EAGLE MOUNTAIN PLANNING COMMISSION MEETING

DECEMBER 9, 2025, 5:30 PM

TITLE:	Horizon Master Community MDP/Plat Review
ITEM TYPE:	Master Development Plan
FISCAL IMPACT:	N/A
APPLICANT:	Caden Hazard

Earlier this year, this matter was noticed as a combination Master Development Plan (MDP) (project is over 50 acres), Rezone (Ag and Country Residential to Foothill Residential), and Preliminary Plat (actually a redo of one entitled years ago). After research was begun as part of this report's generation, it was discovered that in 2024, the passage of Ord. O-49-24 had rezoned the property from Agriculture and Country Residential to Foothill Residential. The City's zoning map had not been updated to show the property as being [now] zoned Foothill Residential by the time the application process was started. Subsequently, the matter was tabled pending resolution regarding how to process the application set. Should a MDP (with an associated preliminary plat) be processed [as applied for] or, rather, should a Preliminary Plat application with a future, standard Development Agreement be developed and used to authorize the project were it to be ultimately approved?

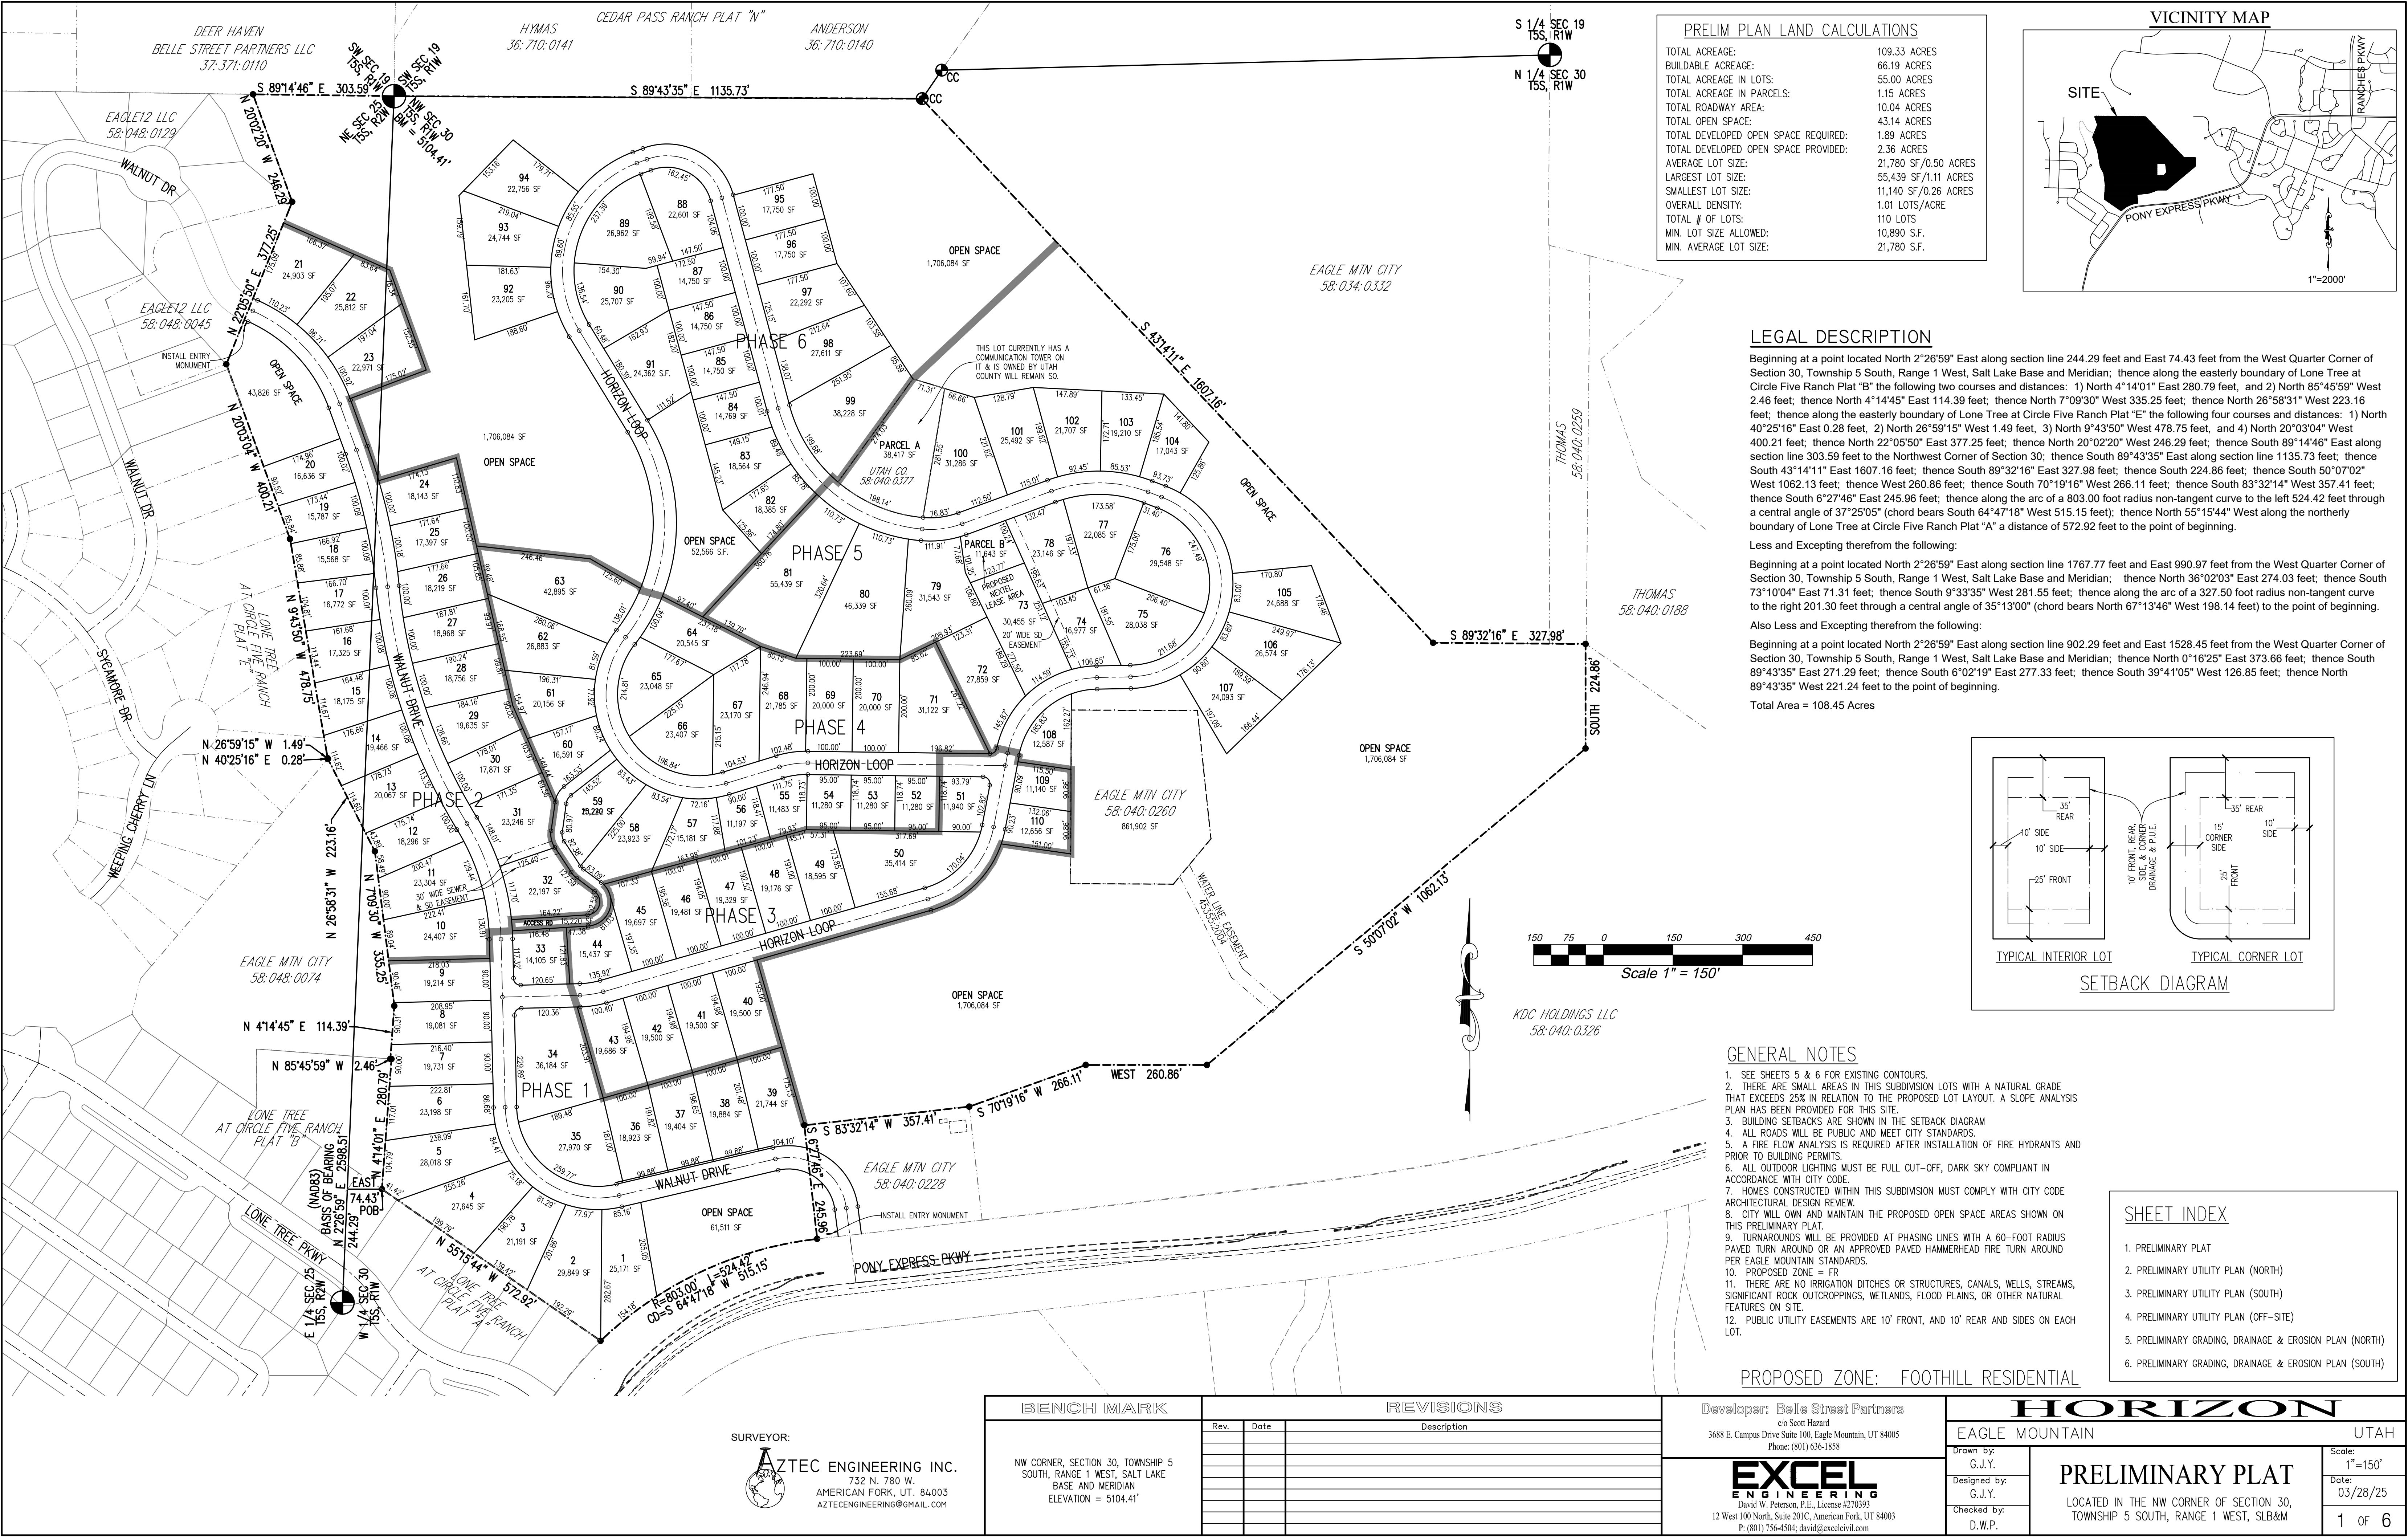
ridgeline setback, except for public trails, structures, and infrastructure. Development within close proximity to prominent ridges shall comply with ridgeline design standards found within this chapter." Again, Staff will, having more time, be able to comment more comprehensively on the proposed plat's conformance to the ridgeline standards. *Seemingly Non-Compliant*

Summary: Staff has questions about the project's status and the following issues [mostly code related] affecting this project's plan/plat design to include: 1. Satisfactory resolution of apparent utility issues (per City Engineering/Public Works); and, 2. Hillside and ridge-line issues; and, 3. Satisfactory resolution of any Wildlife Corridor vector/area issues related to the project; and, 4. Decrease/waiver of caps on "block lengths" where such exceed allowed norms; and, 5. Obtainment of permission or ownership of the City owned Parcel # 58:040:0228 over which the Applicant proposes to construct the main road entry/exit to the development and an accessory 20-stall parking lot on the same parcel; and, 6. Walnut functionality.
